WATER LEVEL INSIDE THE SHROUD VERSUS
 TIME AFTER BREAK STEAMLINE BREAK
 (3.5 SQ. FT.), INSIDE THE CONTAINMENT,
 LPCS DIESEL GENERATOR FAILURE
 FIGURE 6.3-64

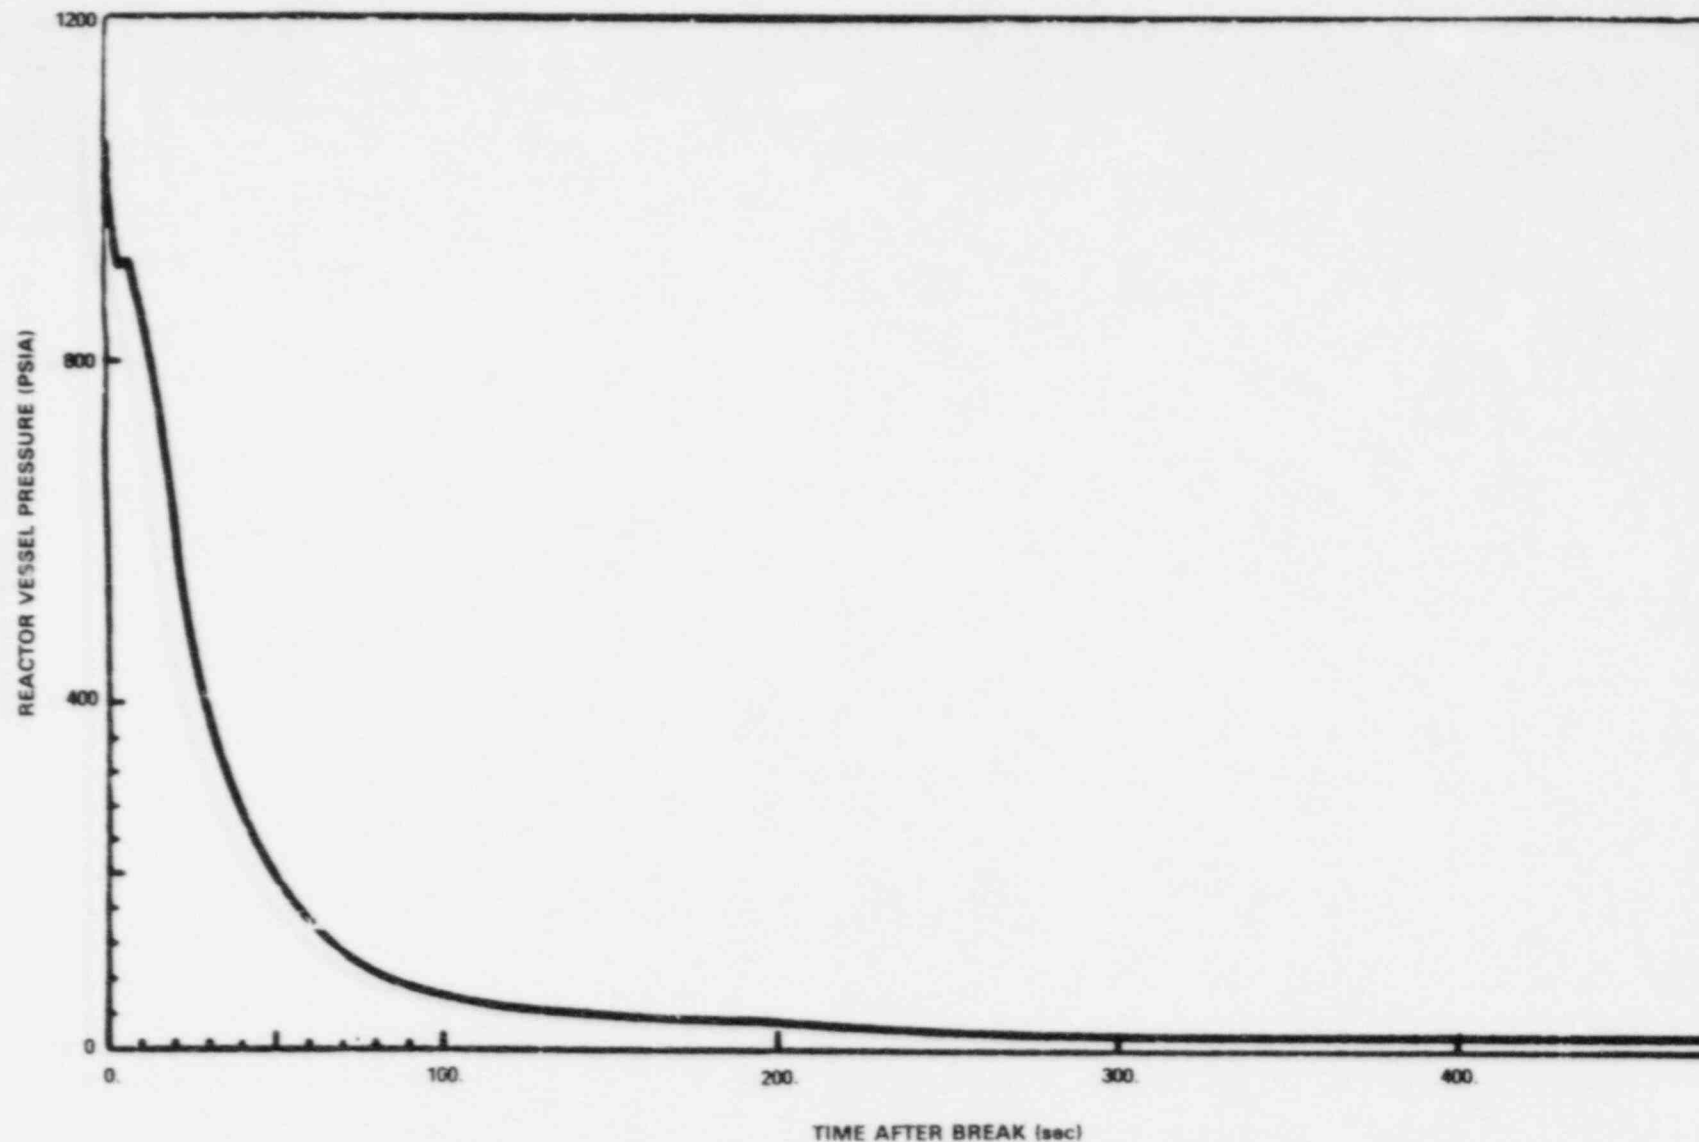
The design basis accident (DBA) steamline break inside the containment was analyzed to determine the effect of starting the ECC systems on low water level only. This event was selected because it was the only event previously in the Grand Gulf FSAR ECCS analysis which took credit for ECCS initiation on high drywell pressure.

For the previous case, the LPCI diesel generator (D/G) was the limiting failure with a calculated PCT of 934°F. The HPCS, LPCS and 1 LPCI systems were assumed to begin injecting at 27, 40 and 40 seconds respectively.
